# ST. MARY'S MEDICAL CENTER

Re: Amendment to License 47-09576-01 to re-locate nuclear cardiology services.

**SUBJECT: Revision to the Report of Venting and Radiation Requirements for the Nuclear Medicine Area of St. Mary's Hospital, Huntington, West Virginia**

# ENLARGED PLAN

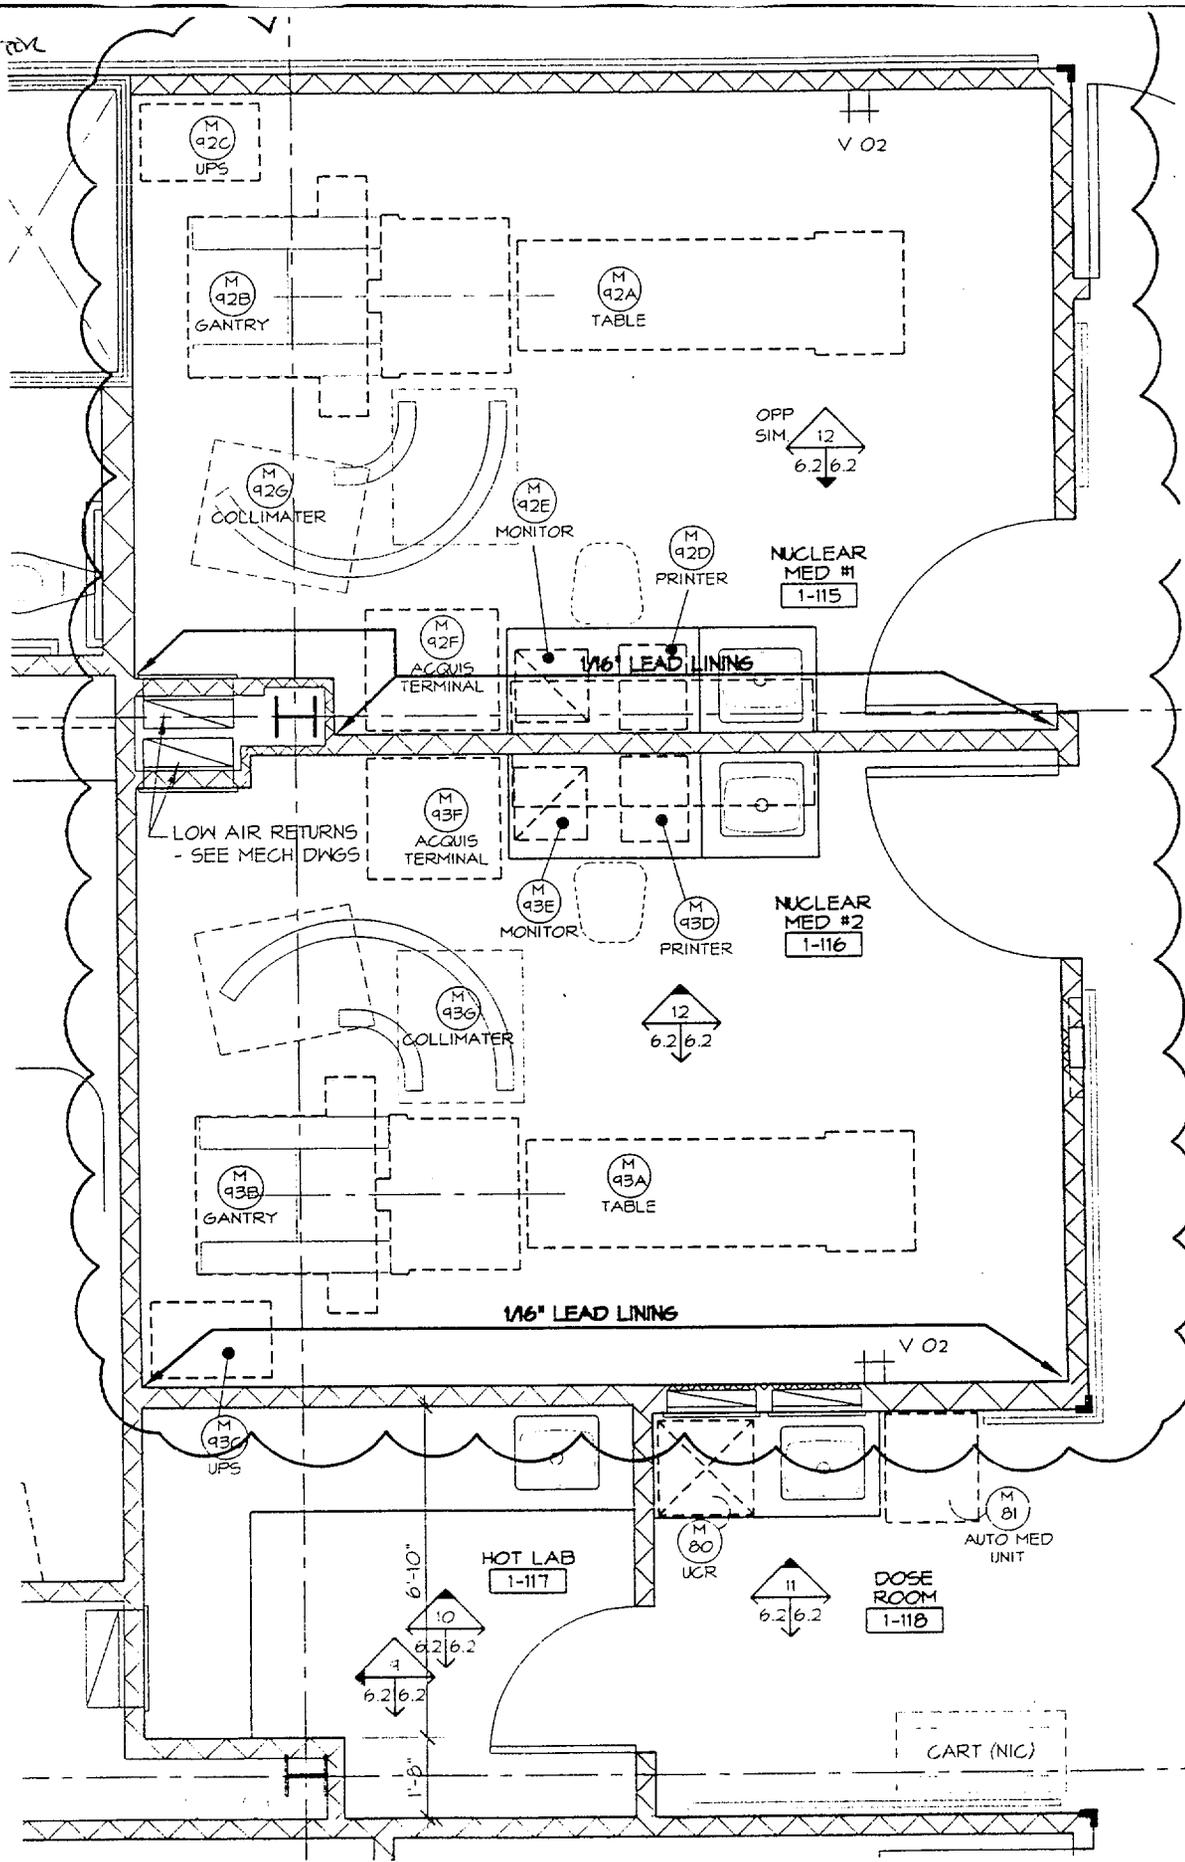
West wall- 1/16 inch lead to 7ft height

West wall-1/16 inch lead to 7 ft height

1. 1/16 inch lead shielding to 7 foot height is required in:

West walls of Nuclear Medicine Rooms #1 and #2- Rm 1-115 and Rm 1-116.

2. The Hot Laboratory will be provided with an exhaust flow of 600 cfm through an exhaust vent installed in the room at workbench height or through a vented hood. An exhaust fan will also exhaust the Nuclear Medicine Rooms (through exhaust vents near the floor) with a flow of 600 cfm per room. Dose Room 1-118 will be provided with an exhaust flow of 600 cfm through a vented hood. The exhaust from this (these) fan (s) will be vented together or separately through a stack(s) at least 7 feet above roof level. The fan(s) will run continuously for 168 hours per week. Nuclear Medicine rooms #1 1-115, #2 1-116, Hot Lab 1-117 and Dose Room 1-118 would be vented together as one group.
